Considerable Dust Development in the Area of the Front Underbody When the Radiator Fan is On (107/25)

Model Line: **Macan (XAB)**

Model Year: **As of 2024**

Underbody panelling (front cover)

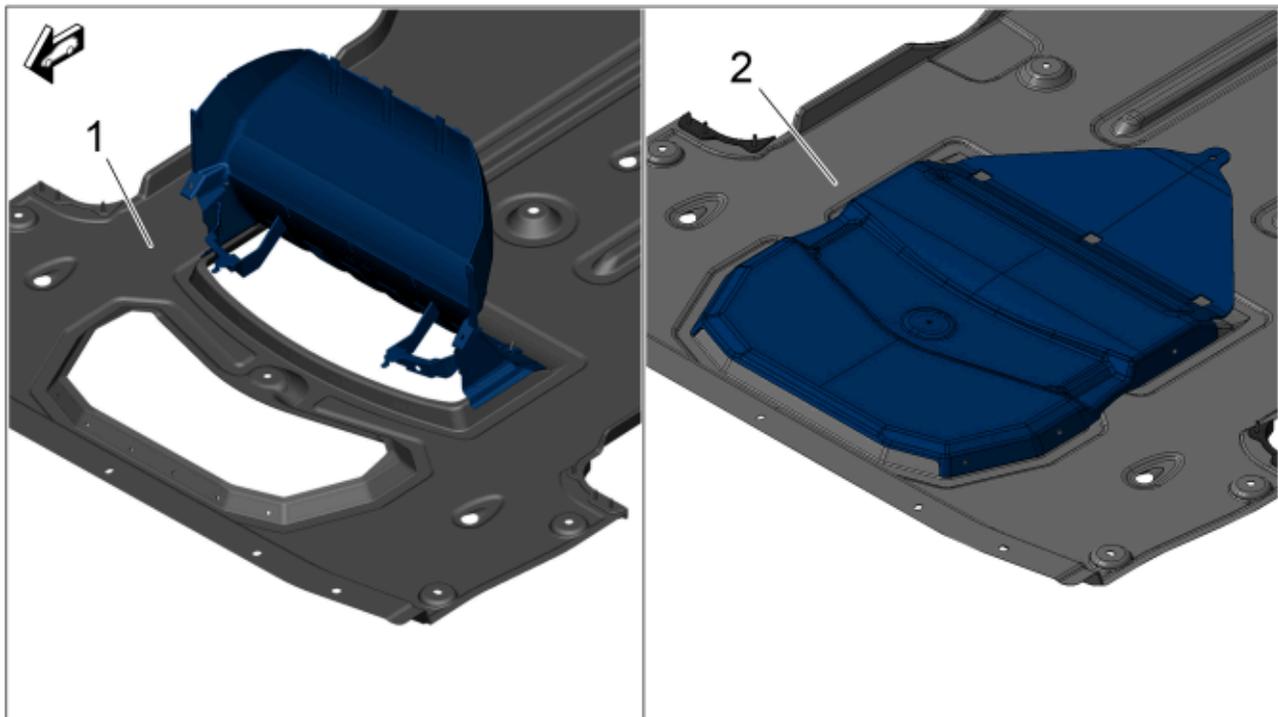
Action: In the event of a customer complaint, inform the customer about the concept-related discharge of the warm exhaust air of the cooling system to ensure the best possible cooling performance of the vehicle.
In the event of customer escalation, it is possible to install a newly developed, closed cover on the underbody panelling (front cover) instead of the previous air guide. This cover reduces the stirring up of road impurities.

- 1 – Underbody panelling with air guide
- 2 – Underbody panelling with closed cover

Lower air guide

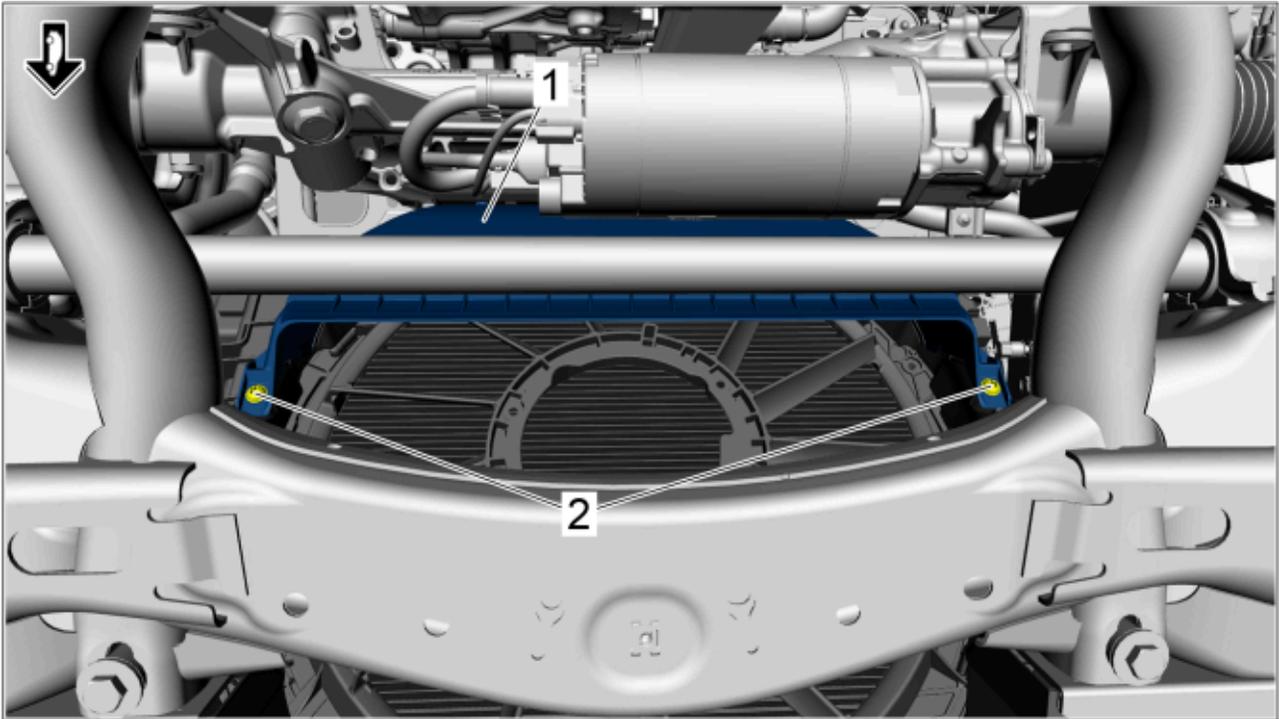
- 2.1 Release and unclip expanding rivet ⇒ *Lower air guide -2-*.
- 2.2 Guide lower air guide ⇒ *Lower air guide -1-* out of the vehicle.
 The **air guide is no longer required** and can be disposed of or given to the customer.
- 3 Remove upper air guide ⇒ *Upper air guide -1-*.

Upper air guide

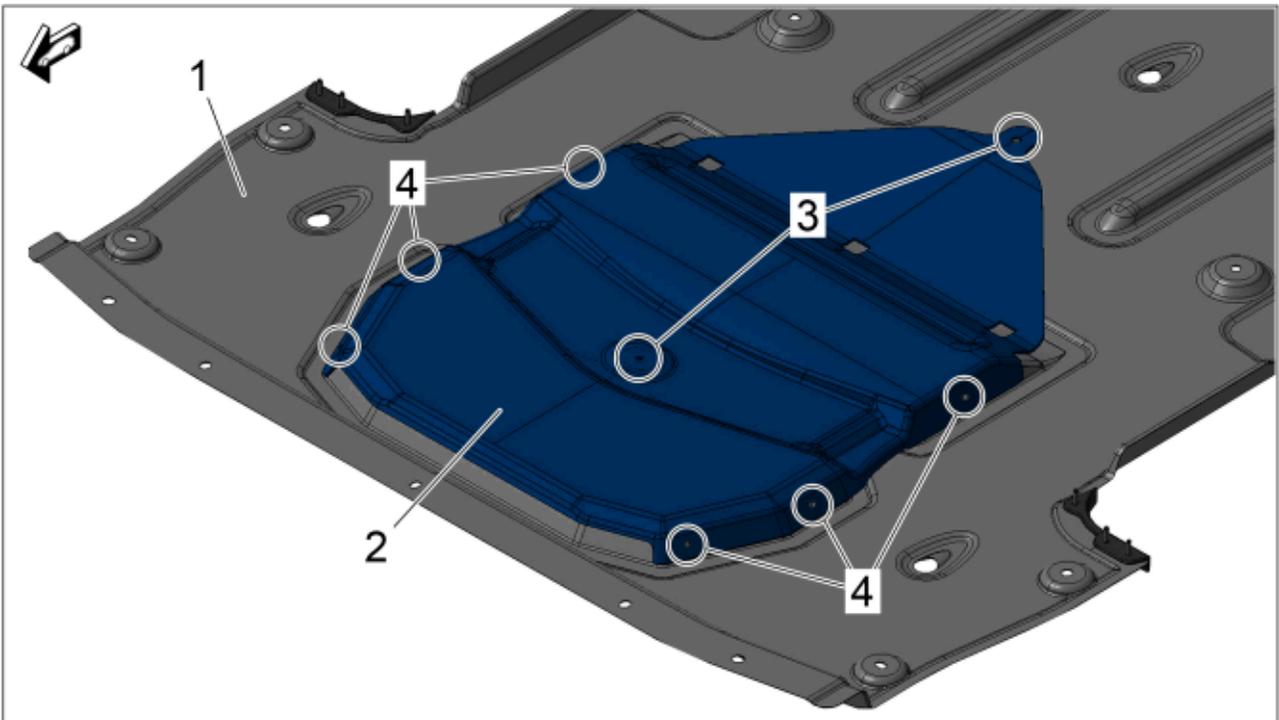
- 3.1 Unscrew screws ⇒ *Upper air guide -2-*.
- 3.2 Guide upper air guide ⇒ *Upper air guide -1-* down and out of the vehicle.
The **air guide is no longer required** and can be disposed of or given to the customer.
- 4 Rework front cover ⇒ *Front cover preparation -1-*.

Front cover preparation

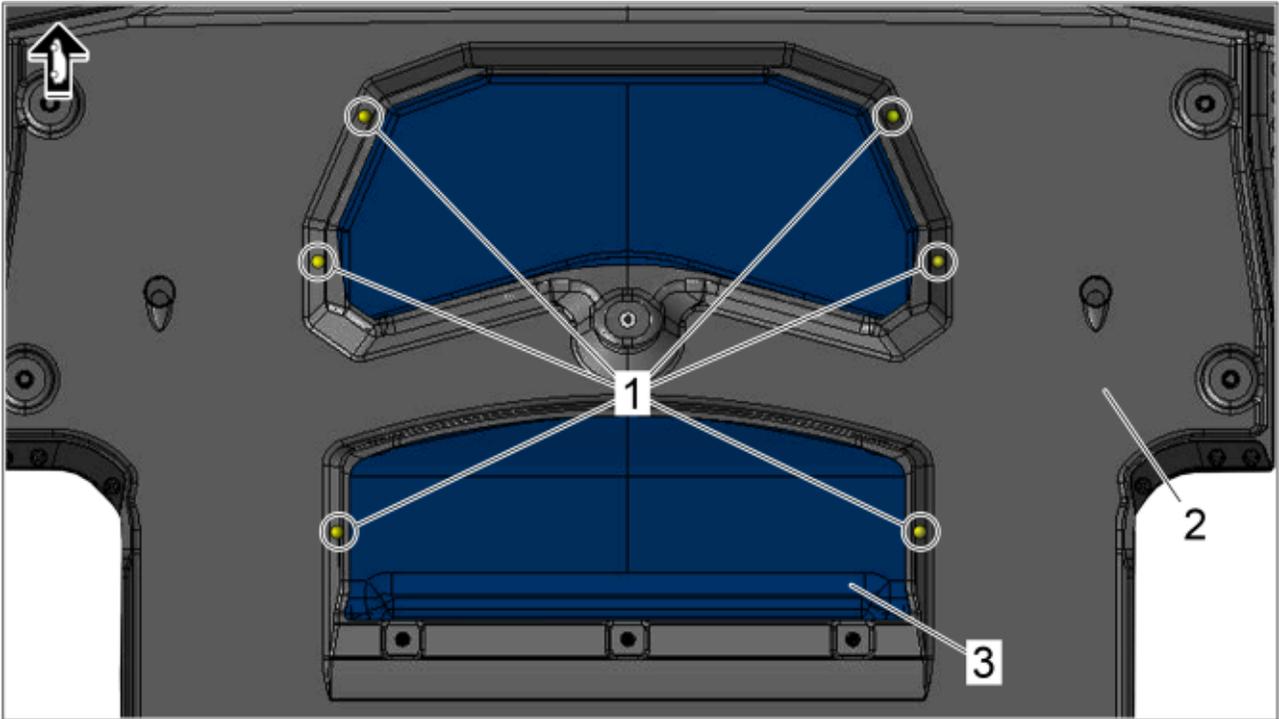
- 4.1 Place new cover ⇒ *Front cover preparation -2-* on front cover ⇒ *Front cover preparation -1-*.
 - 4.2 Align new cover ⇒ *Front cover preparation -2-* using screw points ⇒ *Front cover preparation -3-* and fix in place temporarily with suitable workshop equipment.
 - 4.3 Set 6 holes ⇒ *Front cover preparation -4-* with a Ø 4.5 mm drill bit perpendicular to the surface, drilling through the new cover and front cover ⇒ *Front cover preparation -1-* to do so
 - 4.4 Remove previously attached fasteners and, if necessary, deburr drill holes on both sides.
- 5 Fasten new cover ⇒ *Fastening new cover to front cover -3-* with blind rivet (N 90346301) to fastening points ⇒ *Fastening new cover to front cover -1-* on front cover ⇒ *Fastening new cover to front cover -2-*.
